STAFF'S  
REQUEST ANALYSIS  
AND  
RECOMMENDATION

04PR0262

Bank of Richmond  
(Bank of Richmond)

REQUEST: Site Plan Approval.

DATE	1/25/04
BY	XXX
CHECKED	XXX
APPROVED	XXX
TITLE	SITE LAYOUT PLAN

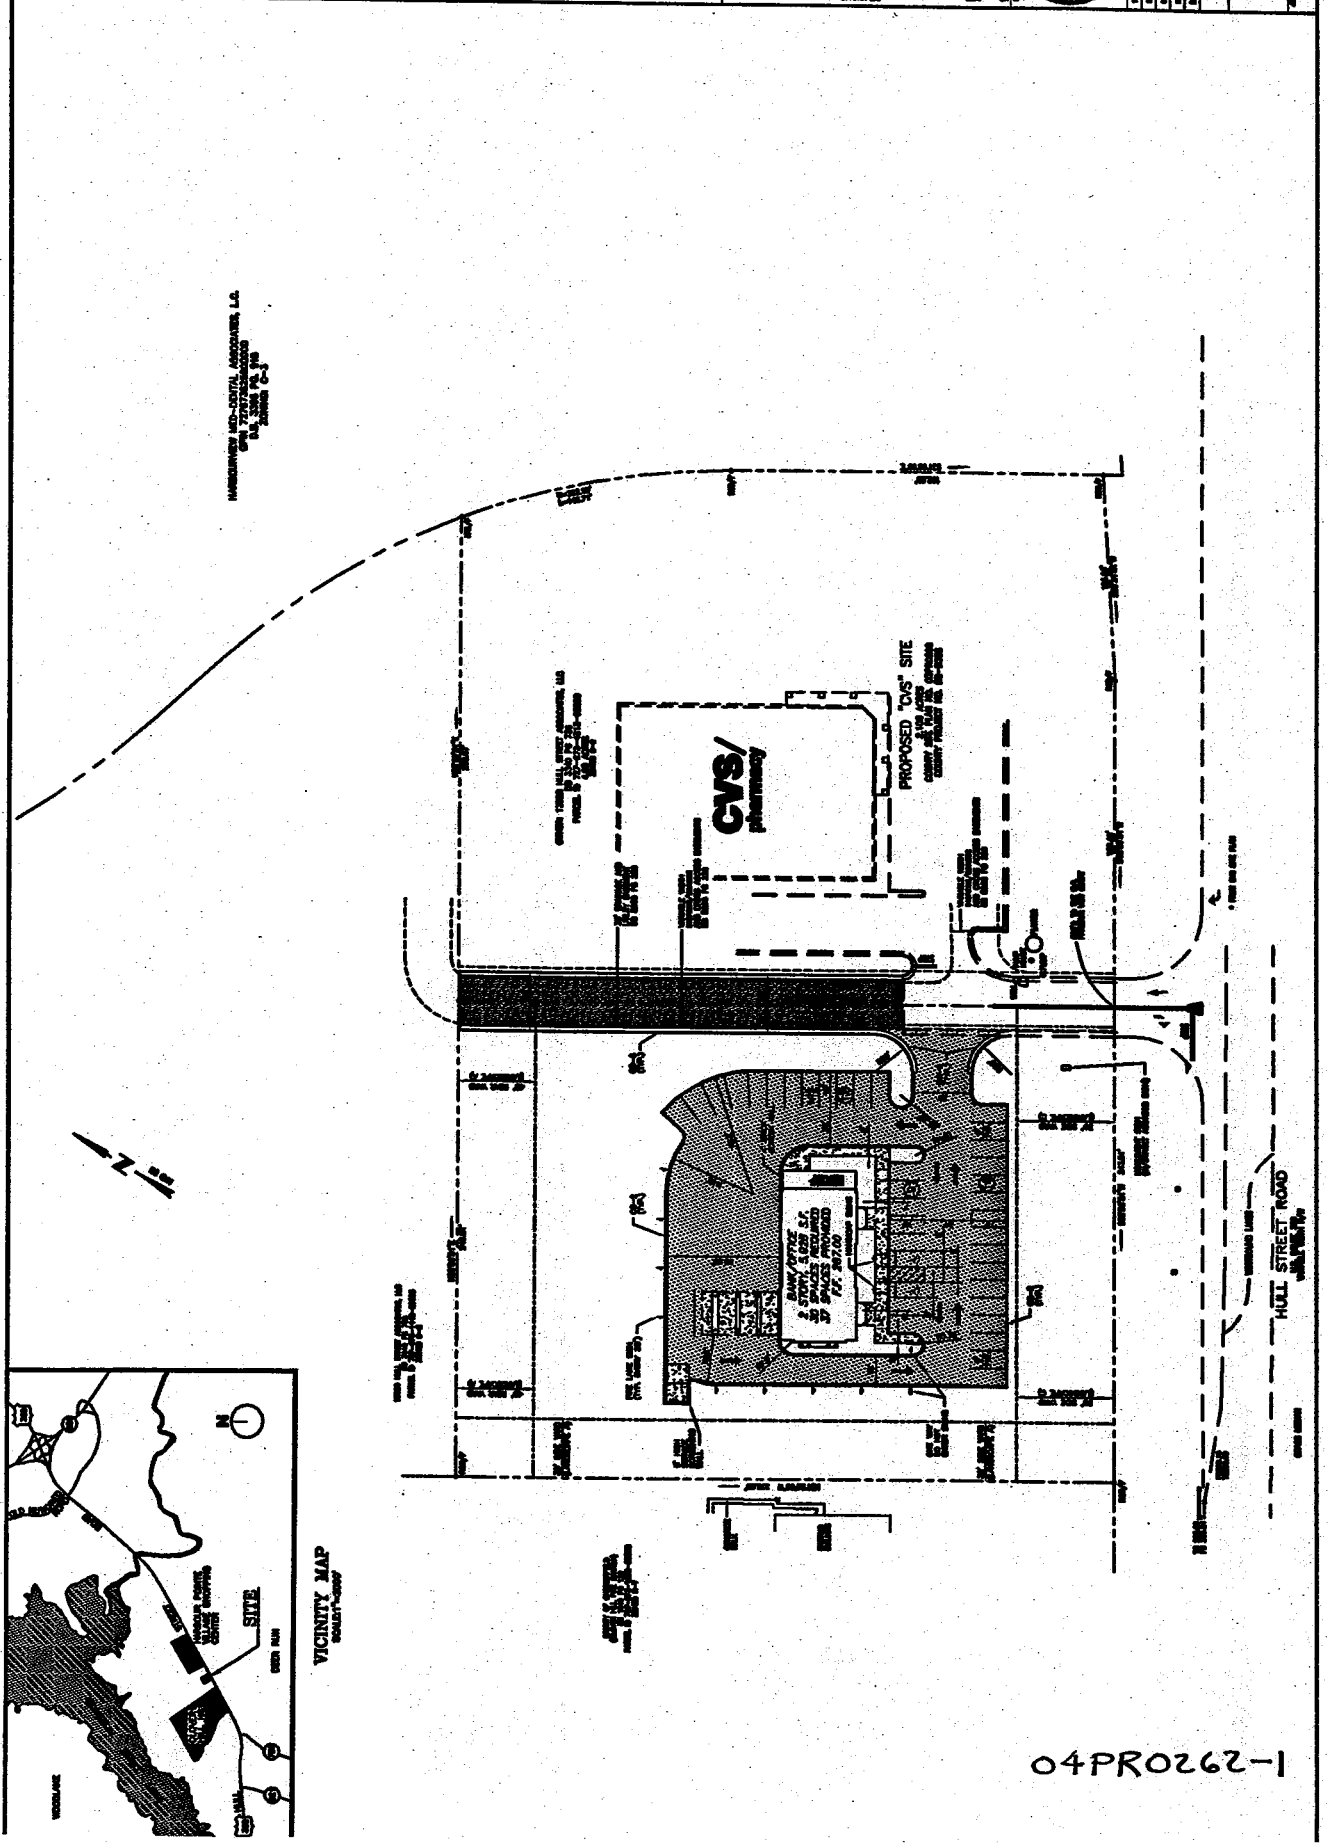
1. When the overall site generates a total of 3,000 average daily trips, construction of a separate right turn lane along 360 at the site entrance will be required. The trips generated by the approved CVS (11,970 square feet) and this proposal total 1,940 average daily trips; therefore, a separate right turn lane is not required at this time. (T)
2. All road improvements associated with the CVS project (County site plan 03PR0299) must be completed prior to the issuance of a certificate of occupancy for this site. (T)

3. The ultimate right of way on 360 in this location is 100 feet measured from the centerline of the road. This right of way must be dedicated, free and unrestricted, to and for the benefit of Chesterfield County, prior to final site plan approval. If it is already dedicated then it must be shown as such on the site plan. (T)

14. Revise the fire hydrant layout. Show a 24 x 6 tapping sleeve and valve, each meter with their own connection to the six (6) inch line, a six (6) inch valve and the fire hydrant at the end of the waterline. (U)

22. A benchmark must be shown with reference to mean sea level. (EE)
23. Provide a VDOT barricade at the terminus of the access road. (EE)
24. In the absence of a detailed soils report, the maximum velocity allowable on bare earth is 3.5 fps. Velocities between 3.5 fps and 4.0 fps require a jute lining and any velocities greater than 4.0 fps require a structural lining of either rip rap or concrete. Address for the outfall channel downstream of Structure 1. (EE)

25. Profiles must be shown for all proposed outfall channels. Address for the open channel downstream of Structure 1. (EE)
26. Top of curb elevations must be shown at the nose of all radial curb and at all appreciable breaks in horizontal or vertical alignment. (EE)

53. The setback off of Hull Street Road must be labeled as fifty (50) foot setback and tree save area, landscape "C" required. Clearing and grading in this area are prohibited. Thinning is only allowed after a review of the setback by staff. (P)

55. Remember that fifty (50) percent of parking area trees must be large maturing trees. Any islands containing large trees must be at least fifteen (15) feet wide. The islands shown may need to be enlarged to meet this requirement. (P)

56. The plantings along the western property line are in conflict with the existing plants on the site. Provide a note indicating that the final location of trees in this area will be determined in the field once grading is complete. (P)

57. A data or "cut" sheet must be provided for all high-intensity light fixtures whether building mounted or pole mounted showing that they are full cut-off fixtures. The traditional style street lamp light fixtures shown are available with internal shielding and flat lens configurations that meet Ordinance requirements. (P)
